S1C17 Family Technical Manual Errata

ITEM	LCD drive voltage		
Object manual	Document code	Object item	Page
S1C17701Technical Manual	411089905	26.4 Analog Circuit Characteristics	26-3
S1C17702Technical Manual	411581702	27.4 Analog Circuit Characteristics	27-3
S1C17704Technical Manual	411511903	26.4 Analog Circuit Characteristics	26-3
S1C17705/703Technical Manual	411706602	25.9 LCD Driver Characteristics	25-10
S1C17706Technical Manual	412026401	27.9 LCD Driver Characteristics	27-7

P19-3(S1C17602,S1C17121,S1C17702,S1C17003,S1C17601,S1C17611)

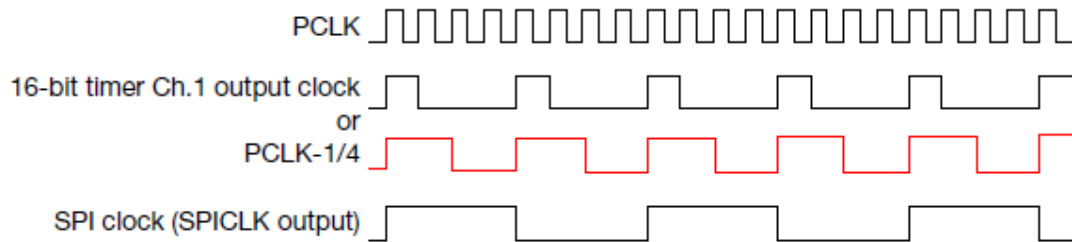
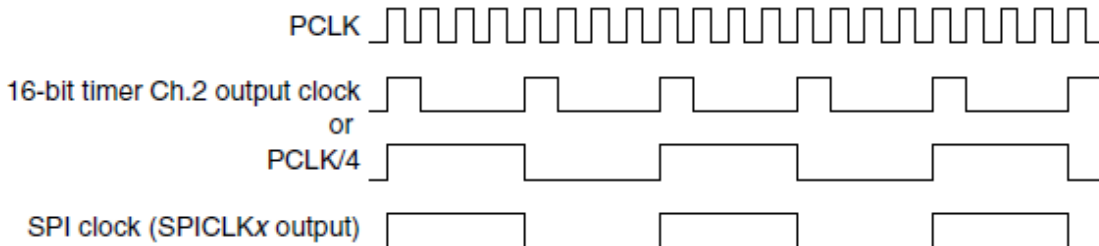
(Error)

The Master mode SPI uses the internal clock output by the 16-bit timer Ch.1 as SPI clock. This clock is output from the SPICLK pin to slave device while also driving the shift register. Use the MCLK(D9/SPI_CTL register) to select to use the 16-bit timer ch.1 output clock or PCLK-1/4 clock. Setting MCLK to 1 selects the 16-bit timer Ch.1 output clock; setting to 0 selects to 0 selects the PCLK-1/4 clock.

The Master mode SPI uses the internal clock output by the 16-bit timer Ch.1 as SPI clock. This clock is output from the SPICLK pin to slave device while also driving the shift register. Use the MCLK(D9/SPI_CTL register) to select to use the 16-bit timer ch.1 output clock or PCLK-1/4 clock is used. Setting MCLK to 1 selects the 16-bit timer Ch.1 output clock; setting to 0 selects to 0 selects the PCLK-1/4 clock.

Figure 15.3.1 Master Mode SPI Clock

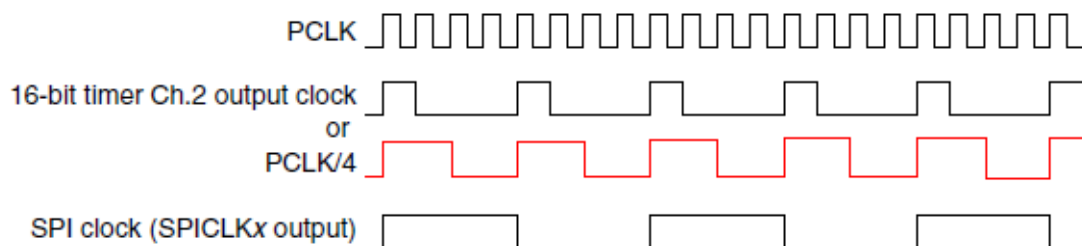
(Error)

(Correct)

Figure 15.3.1 Master Mode SPI Clock

Figure 19.3.1 Master Mode SPI Clock

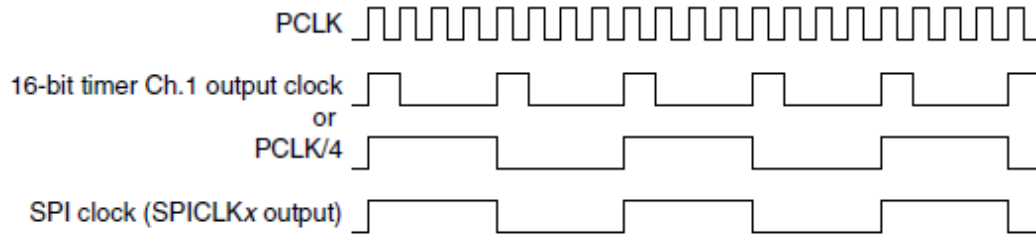
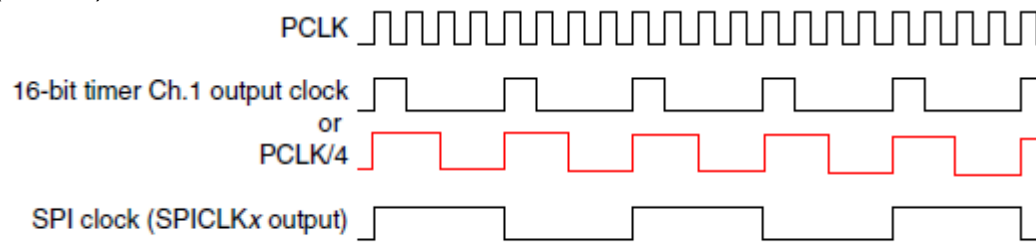
**P19-3(S1C17621/S1C17602/S1C17622/S1C17604/S1C17624)**

(Error)

(Correct)

Figure 19.3.1 Master Mode SPI Clock

Figure 19.3.2   Slave mode SPI clock

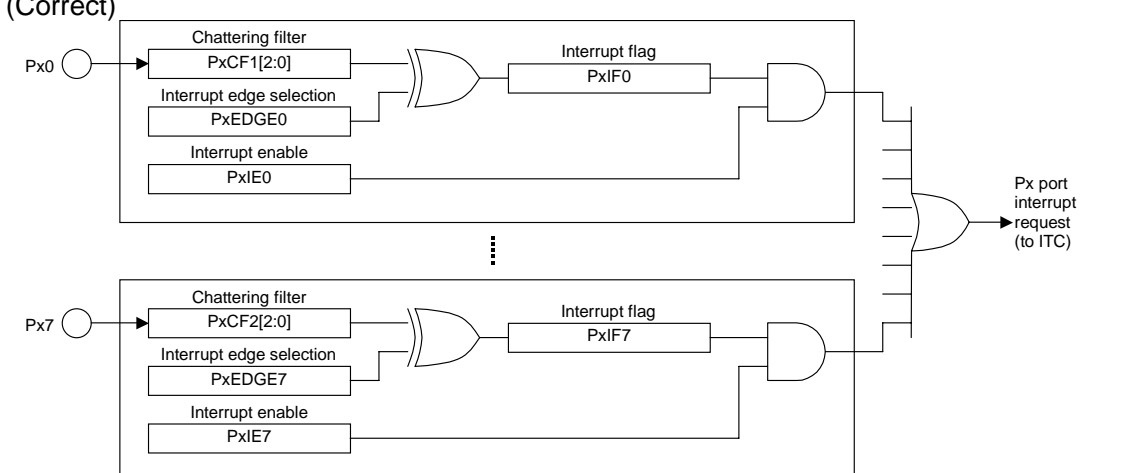
(Error)

Note: The frequency of the clock input via the SPICLK pin must be less than 1/3 of the PCLK and have a clock duty ratio of 50%.

Note: The duty ratio of the clock input via the SPICLK pin must be less than 1/3 of the PCLK and have a clock duty ratio of 50%.
